**RE: Lot 7 Block 4 Unit 19 SAD 228
6532 Azor Lane NW
Volcano Cliffs Subdivision
Grading and Drainage Plan
Engineers Stamp Date 5/7/18 (D10D003T7)**

Based upon the information provided in your submittal received 5/21/18, this plan is approved for Pad Certification.

ENGINEER'S SEAL	Title 6532 AZOR LANE NE	DRAWN BY	
		DATE	
5/07/18	GRADING AND DRAINAGE PLAN	DATE	
		SHEET #	
Richard Dourte P.E. #10854		1 of 1	
		JOB #

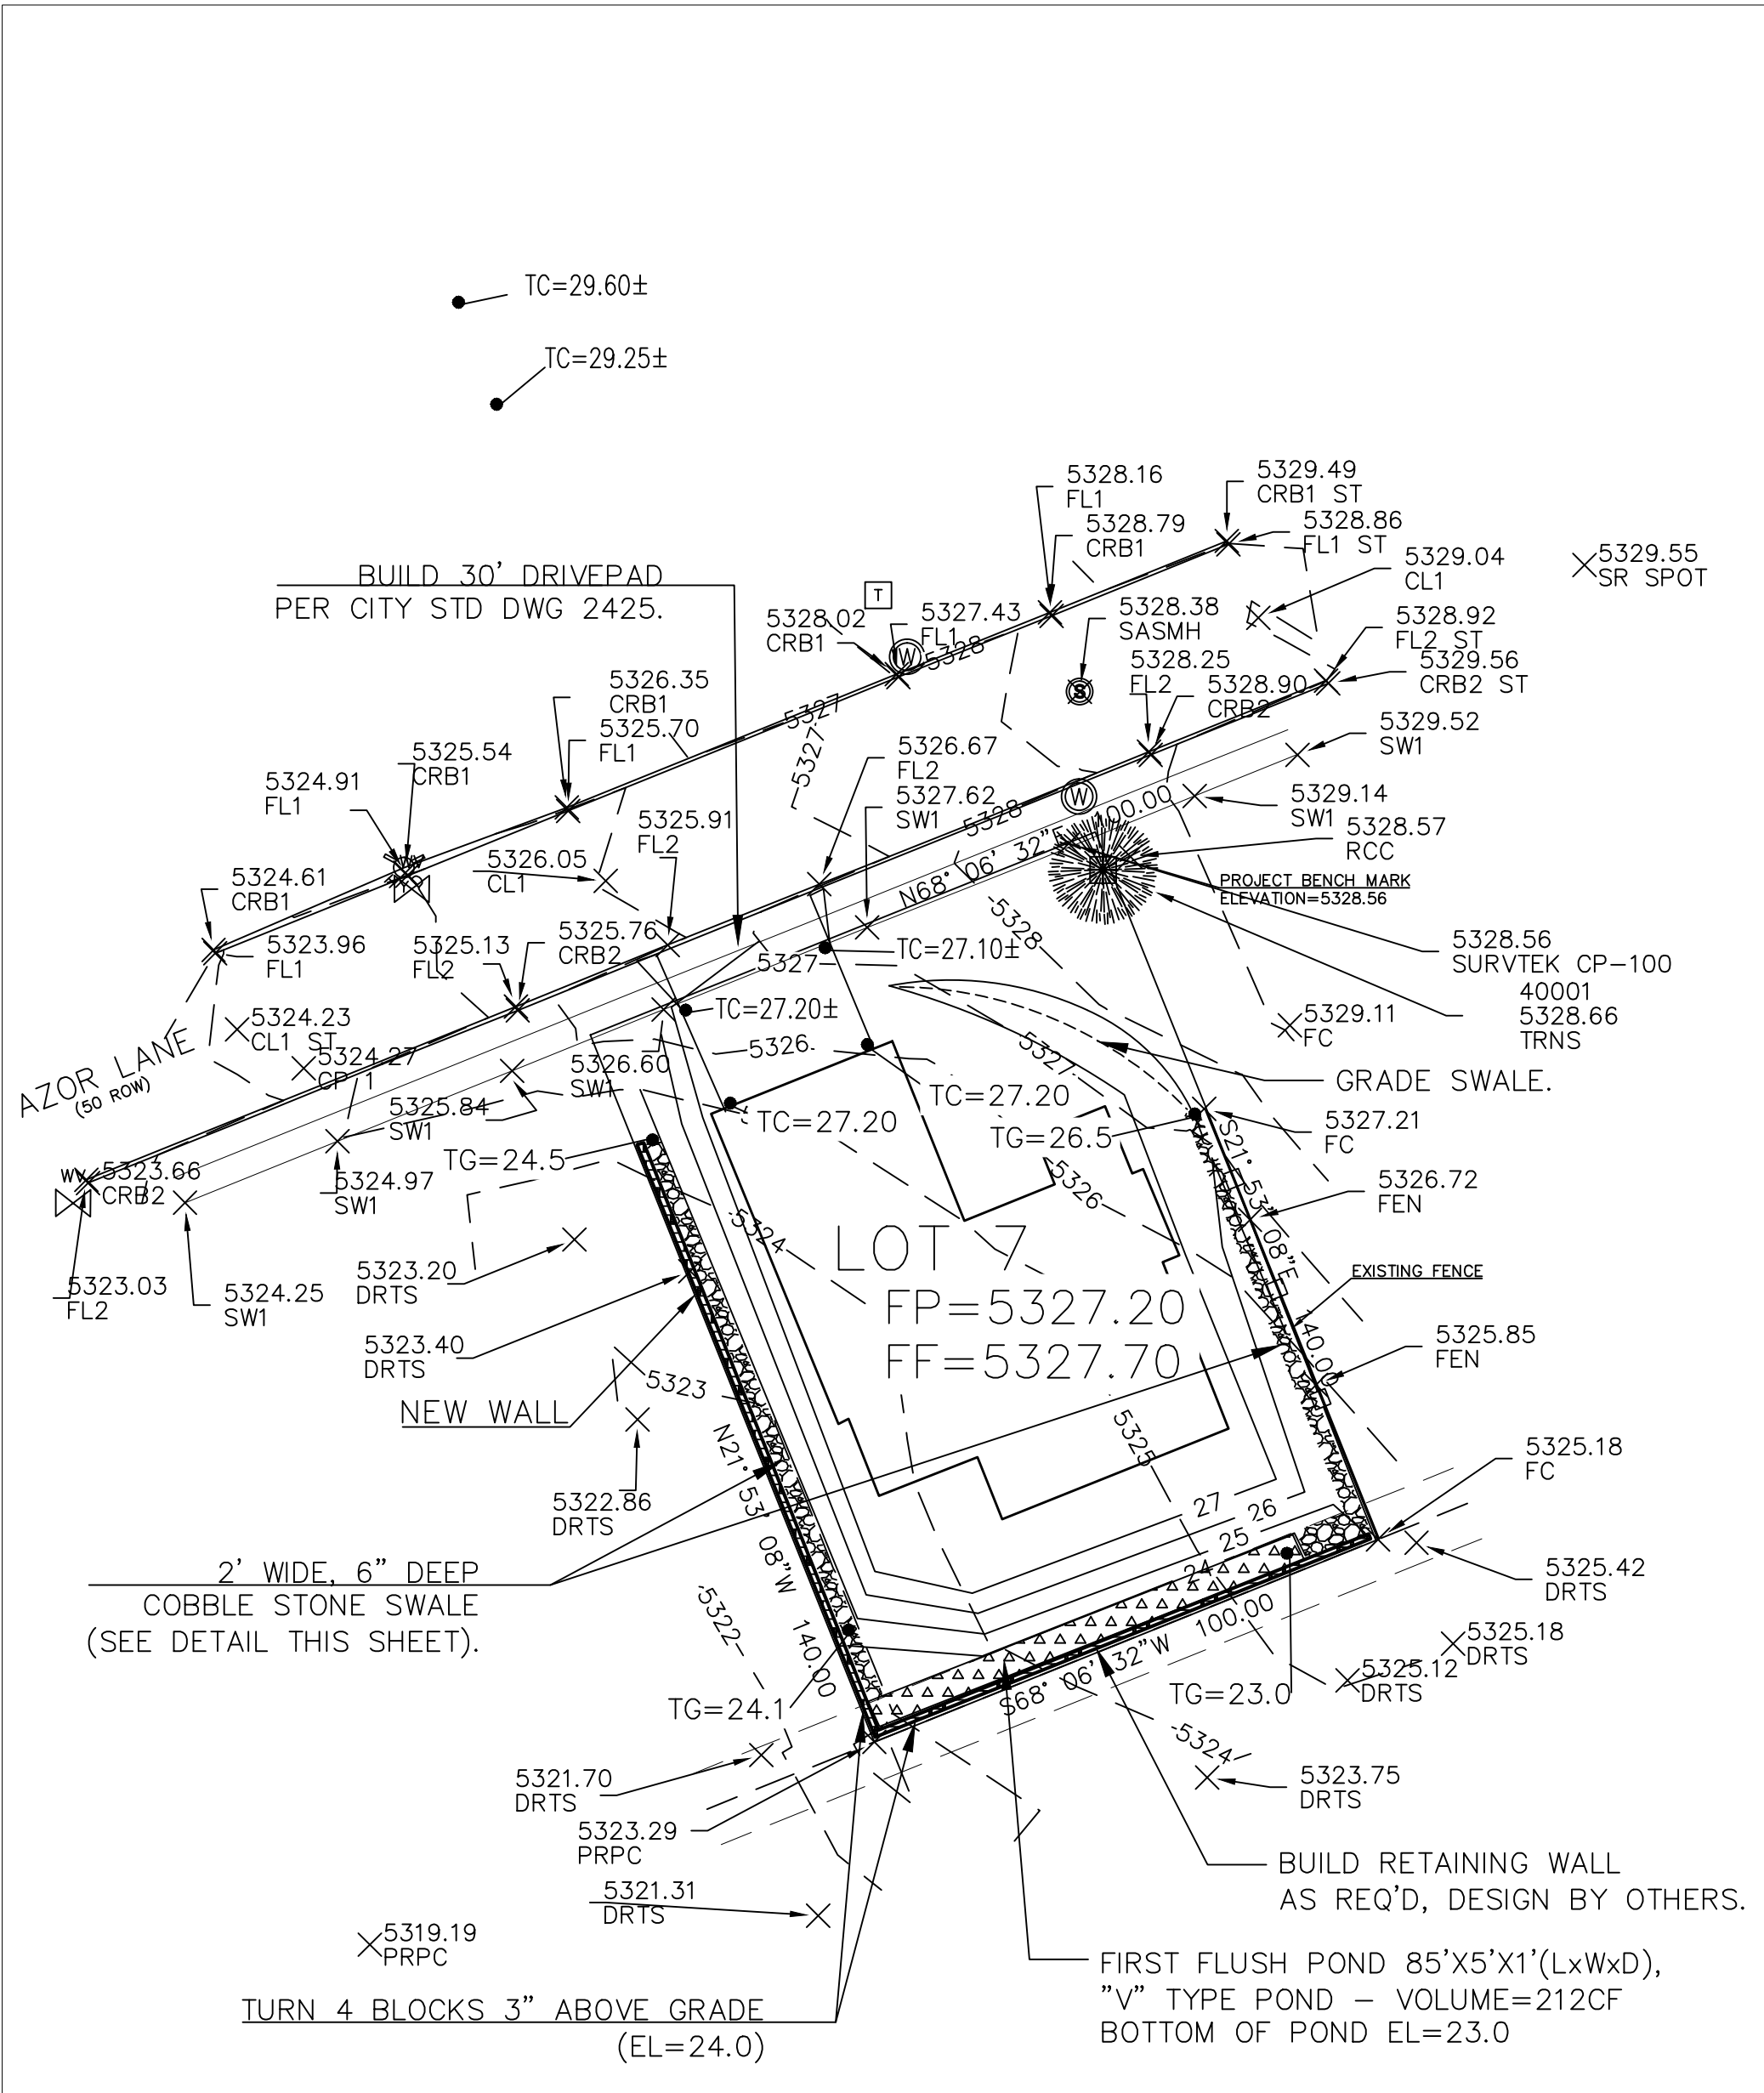
Reiterate to the Owner/Contractor that a separate permit for a garden/retaining wall must be obtained, with the approved G&D plan.

Prior to Certificate of Occupancy release, Engineer Certification per the DPM checklist of this plan will be required.
